Geotechnical Report
Plan Review/Recommendations for Slope Protection at
Sand Canyon Overcrossing on Route 14

File: 07-LA-14 PM 33.4
EA: 07-272-258801
E-FIS: 0700020195
Slope Protection/Sand
Canyon OC

Subject: Plan Review/Recommendations for Slope Protection at Sand Canyon Overcrossing on SR14

FIGURE 2. RECOMMENDED STABILIZATION MEASURES (SCHEMATIC)

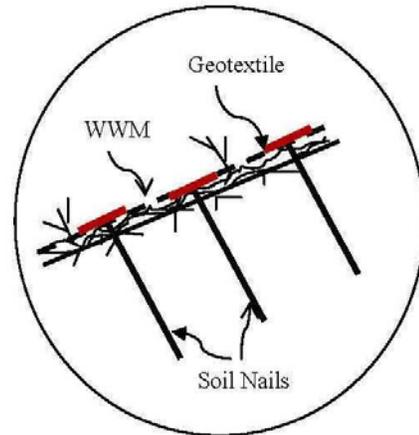
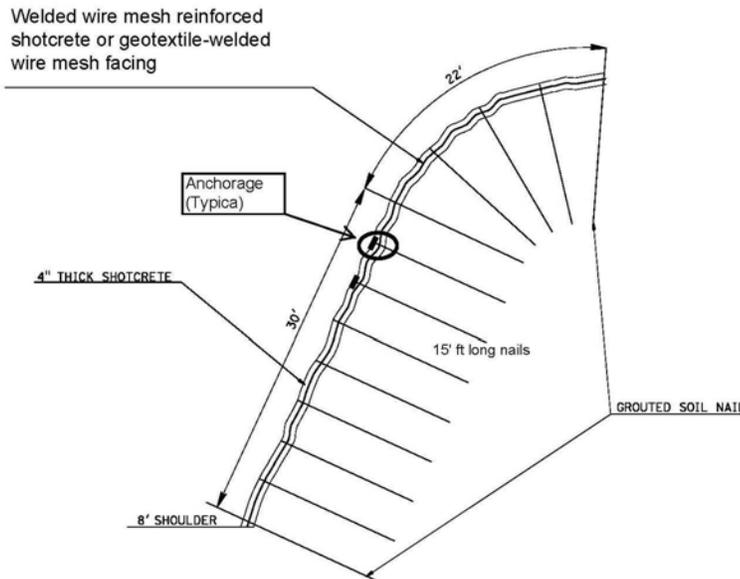
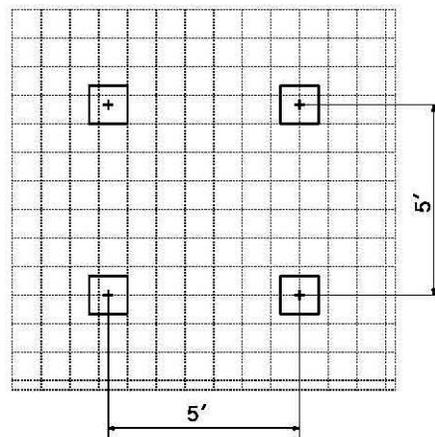
1. We recommend that the subject slopes be protected by installing a surficial slope stabilization measures consisting either a wire-reinforced shotcrete or a geotextile-wire mesh facing anchored with grouted soil nails, as shown schematically in the attached Figure 2.

- iii. Install Soil Nails: Drill holes and install 15 feet long threaded grouted nails (#6 or 7 Grade 60) in a grid pattern (5 ft by 5 ft) as shown schematically in the attached Figure 2. The soil nails should be double corrosion protected.
- iv. Install Facing: Install welded wire mesh (6"x 6" W2xW2) reinforced shotcrete facing (≥ 4 inch thick) or geotextile-welded wire mesh facing. Either Type A or Type geotextile fabric as defined in Section 88-1.04 of the Caltrans' Standard Specifications may be used.
- v. Anchor Facing: Install and tension 10" by 10" square, $\frac{3}{4}$ " thick bearing plates over the soil nail heads. The tension force should be on the order of 1.5 to 2.0 kips. If shotcrete facing is used, tensioning should be performed once the shotcrete has developed adequate strength.
